ANN ARBOR HISTORIC DISTRICT COMMISSION

Staff Report

ADDRESS: 812 W Washington Street, Application Number HDC13-146

DISTRICT: Old West Side Historic District

EXISTING NORTH/REAR

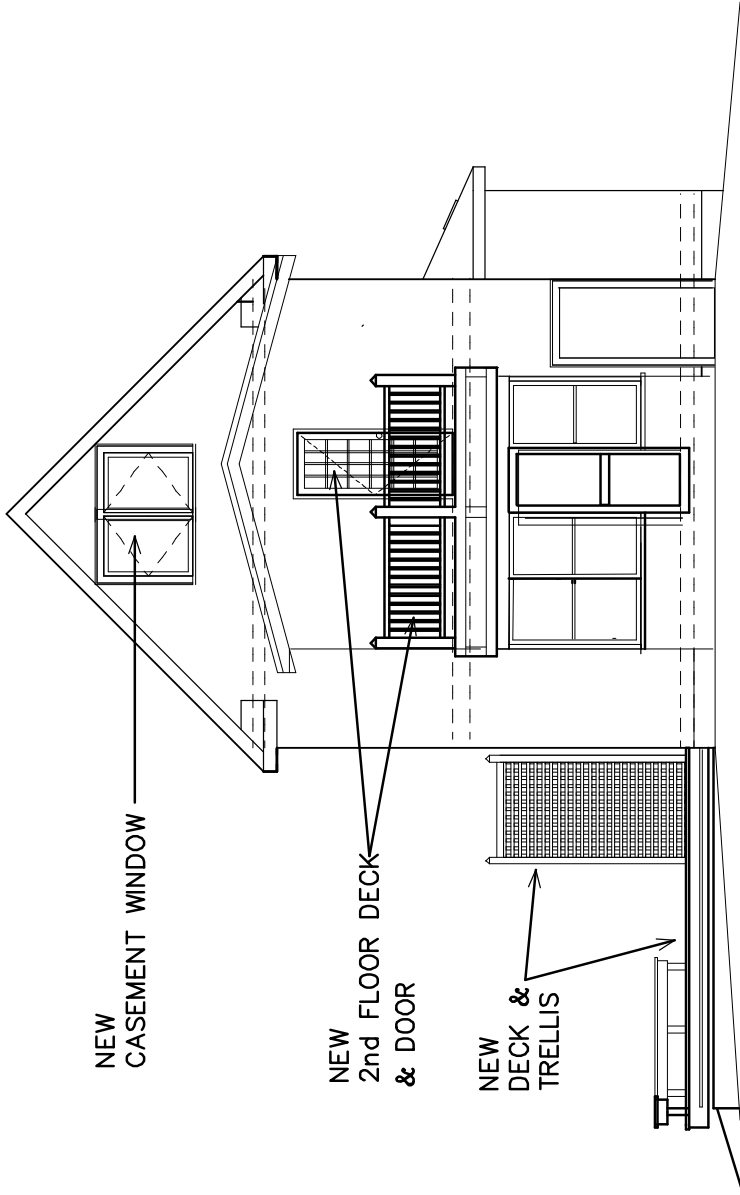
7. Removing the egress door and stair on the west elevation is highly appropriate.
8. One small square window is proposed to be removed from within the gable on the back of the main house block, and replaced with a double casement window. The dimensions of the casement window are not provided, but the window appears very large in the drawings. Staff feels the window is acceptable because it will provide daylight and serve as an egress window for the third floor, and because there are only a few angles from which the window will be clearly visible (it is hidden behind the two-story rear wing from many perspectives).

9. The double hung window on the rear wall of the rear wing is proposed to be removed and enlarged into a doorway, with a deck constructed on top of the existing rear porch. Since this is neither a primary nor a character-defining elevation, and because the roof has already been altered on this section of the house, staff feels this work is appropriate. The deck could easily be removed in the future and the porch roof restored to its original appearance.

I move that the Commission issue a certificate of appropriateness for the application at 812 West Washington Street, a contributing property in the Old West Side Historic District, to: remove the chimney; remove the non-original east window, and replace the non-original west window with a double hung window that is wood or matches the material of the other double hung windows on the house; replace the non-original front door; install skylights on the rear wing's east roof and the west elevation bump out; remove a door and wood fire escape stairs; remove a square window in the rear gable and install a larger casement window; and replace a window on the rear elevation with a door, and construct a roof deck on top of the rear porch, as proposed. The work is compatible in exterior design, arrangement, texture, material and relationship to the rest of the building and the surrounding area and meets *The Secretary of the Interior's Standards for Rehabilitation and Guidelines for Rehabilitating Historic Buildings*, in particular standards 2, 9 and 10 and the guidelines for roofs, entrances and porches, windows, and building site, as well as the *Ann Arbor Historic District Design Guidelines*, particularly as they pertain to doors and windows.

EXISTING WEST/SIDE

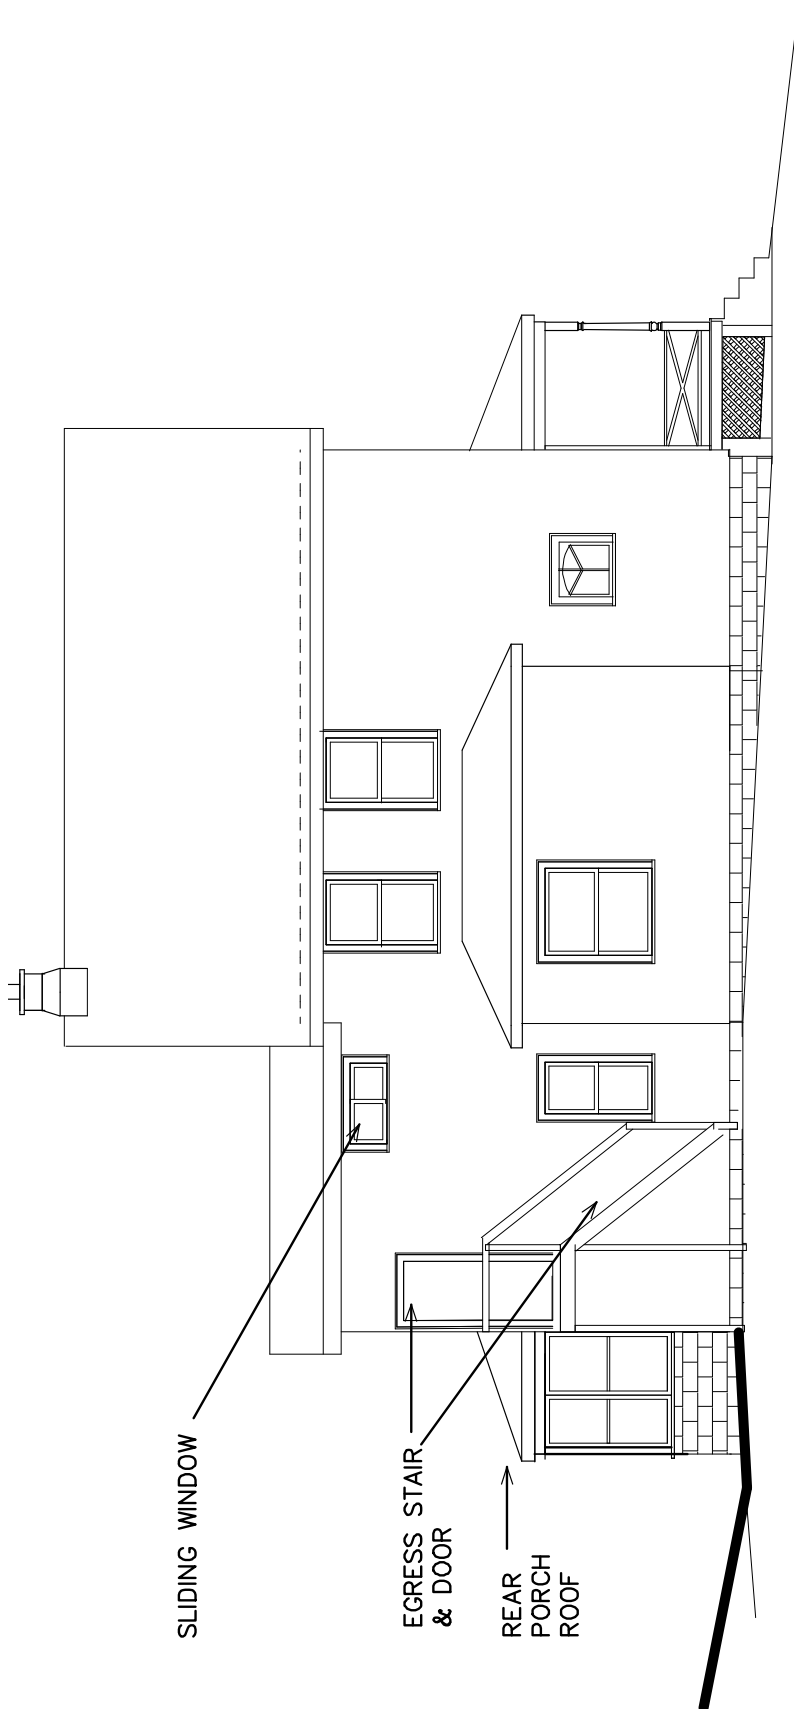
5. A dining room window on the first floor of the west elevation is proposed to be removed and replaced by double french doors leading to a new deck with a trellis along the side facing the street. The west side of the house is very visible, and staff considers it to be a primary, character-defining elevation. The installation of a new door opening is not appropriate on a primary elevation. Without a door leading to it, the deck is also not appropriate. There is room behind the house for a patio or deck off of the existing door openings.

11. Staff believes the following work does not meet the SOI Standards and Guidelines, and/or the *Ann Arbor Historic District Design Guidelines*: installing a new door wall and

deck on the west elevation of the main house block; and installing two skylights on the east roof of the main house block. (Second proposed motion.)

I move that the Commission issue a certificate of appropriateness for the application at 812 West Washington Street, a contributing property in the Old West Side Historic District, to: remove a window and install a new door wall and deck on the west elevation of the main house block; and install two skylights on the east roof of the main house block, as proposed. The work is compatible in exterior design, arrangement, texture, material and relationship to the rest of the building and the surrounding area and meets *The Secretary of the Interior's Standards for Rehabilitation and Guidelines for Rehabilitating Historic Buildings*, in particular standards 2, 9 and 10 and the guidelines for roofs, entrances and porches, and building site, as well as the *Ann Arbor Historic District Design Guidelines*, particularly as they pertain to doors and windows.
